DESIGN REVIEW COMMITTEE

AGENDA

4.I. 3396 Dogwood Drive Addition

PLANNER'S REPORT

SITE PLAN

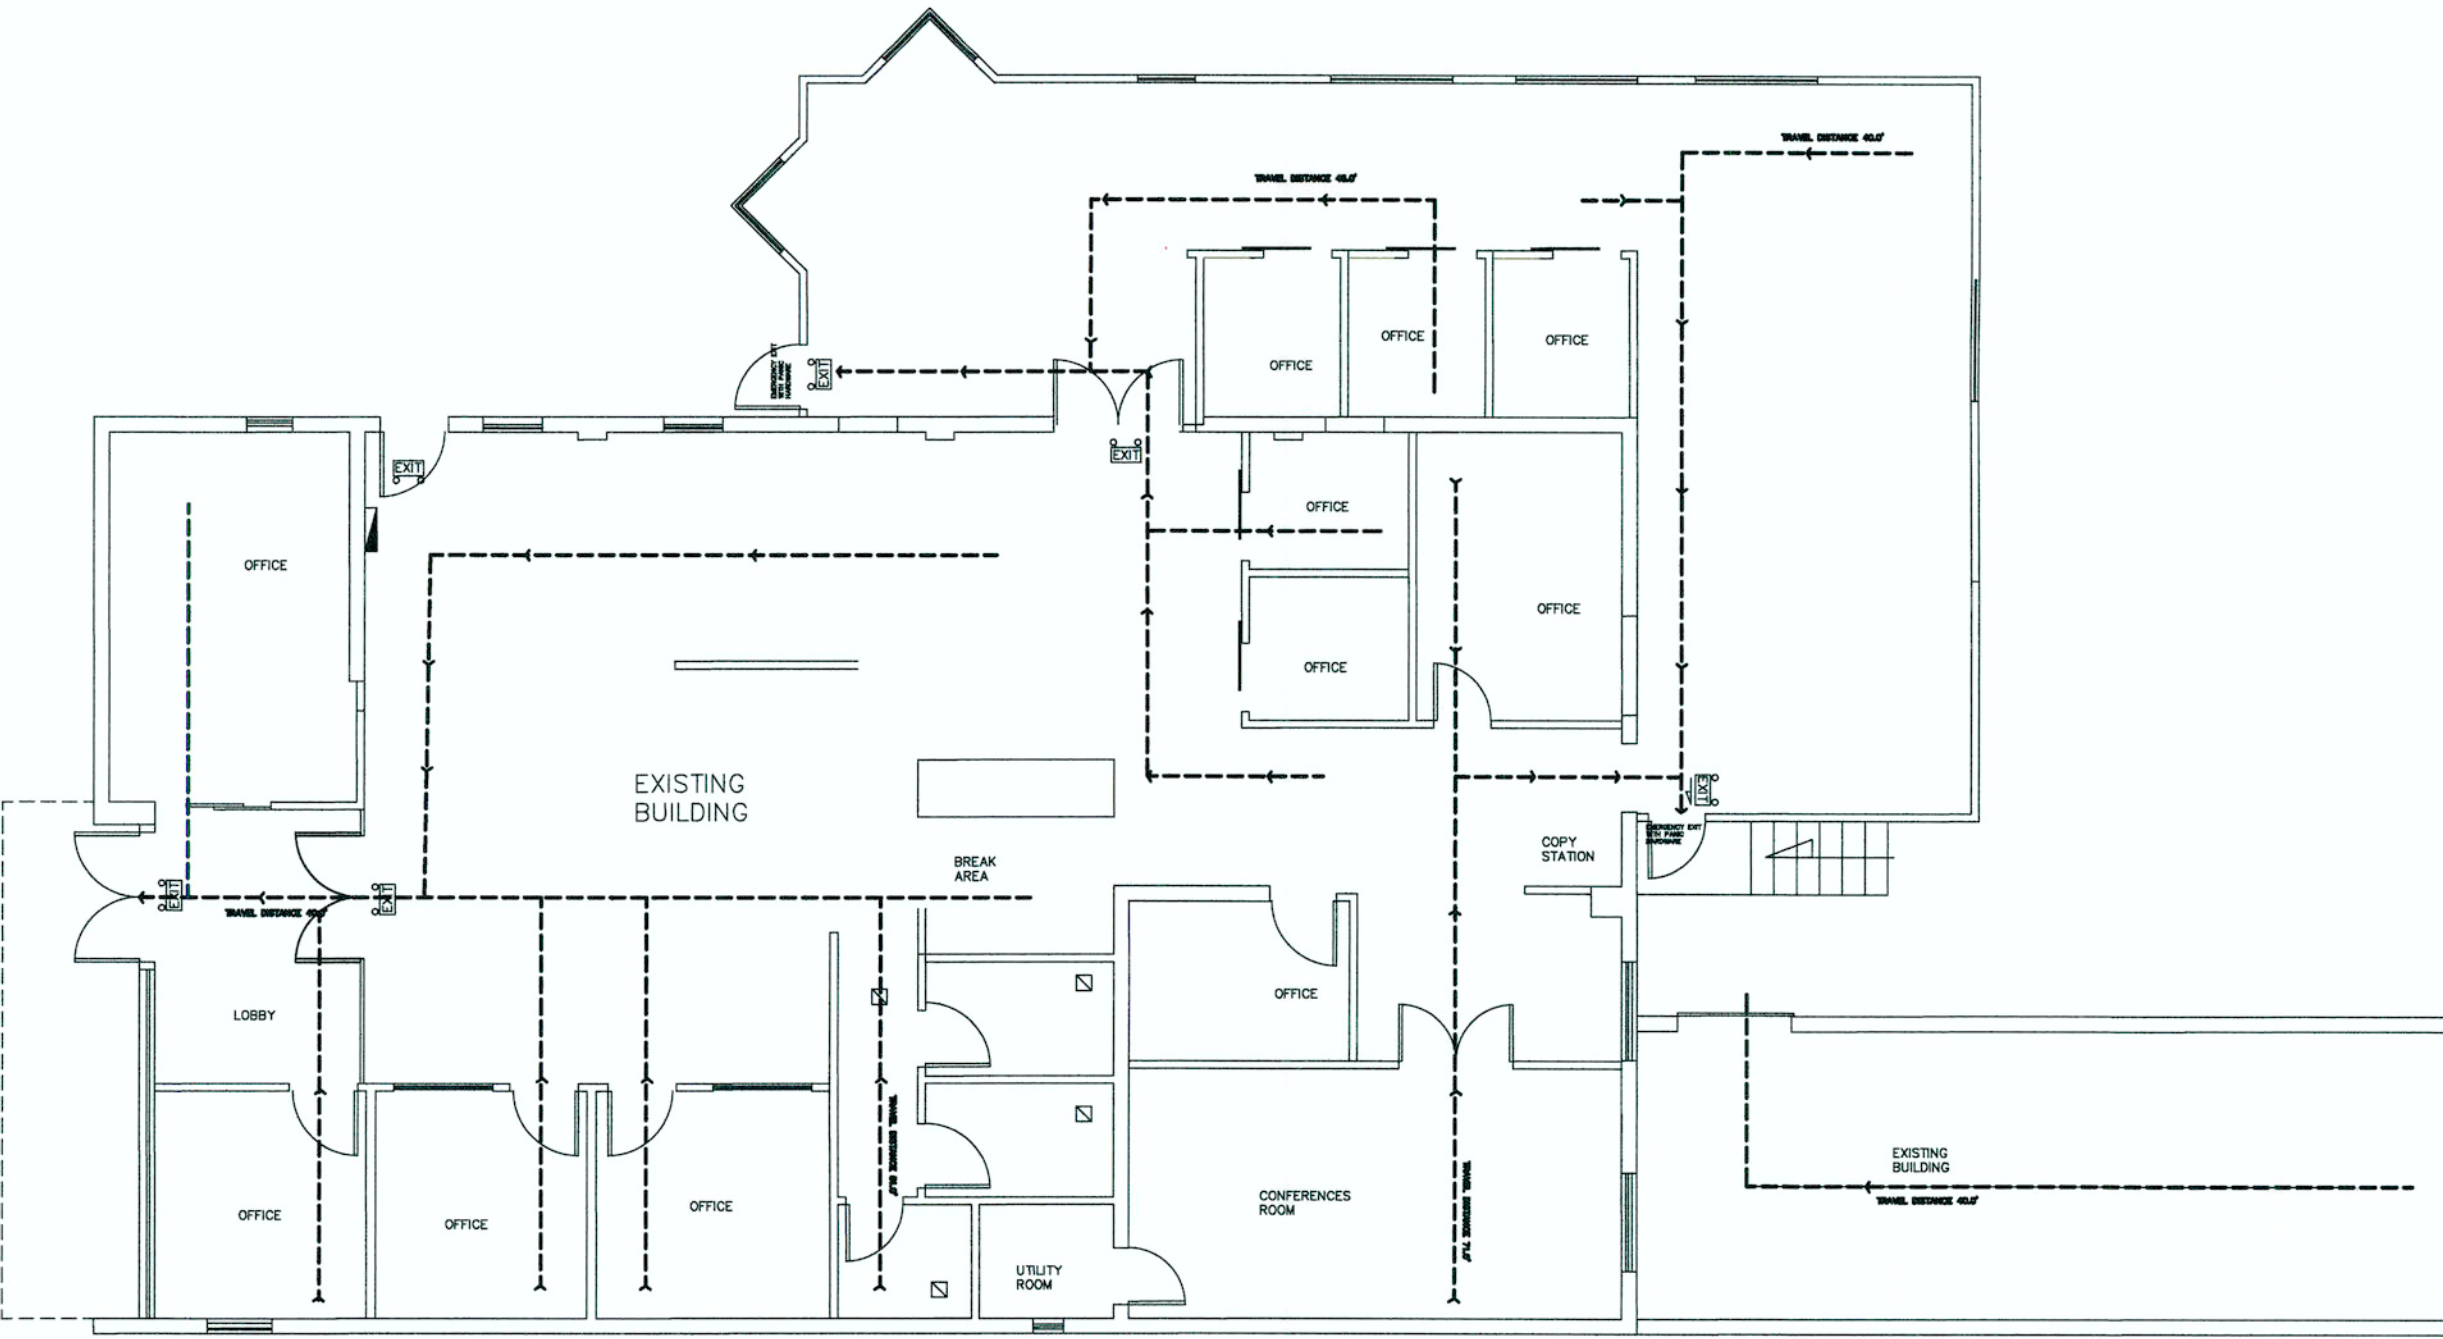
Provide parking lot diagram (dimensioned) to show compliance with parking spaces (12 minimum) and layout.

Provide driveway width to show compliance.

Provide building numbers at the front entrance.
